# Waterbeach New Town Supplementary Planning Document (SPD)

## Statement of Consultation

Fig. 19 | Access Movement and Connectivity

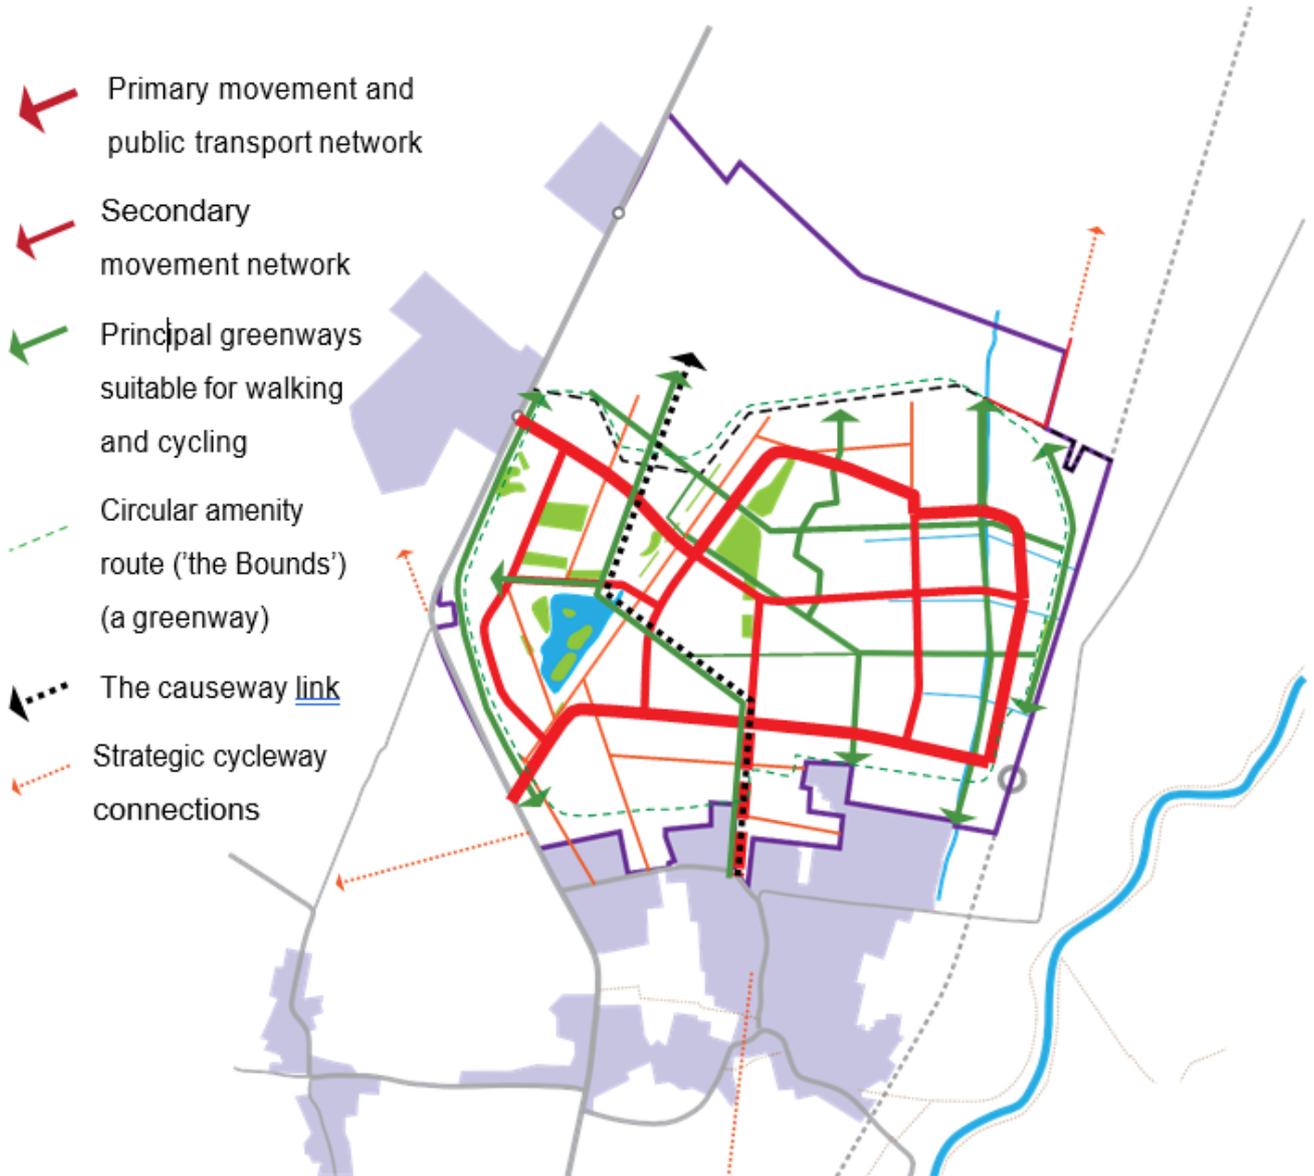
Agree that the Greenways shown on Figure 19 would be easier to locate if shown in green rather than red to avoid confusion with the road designations.
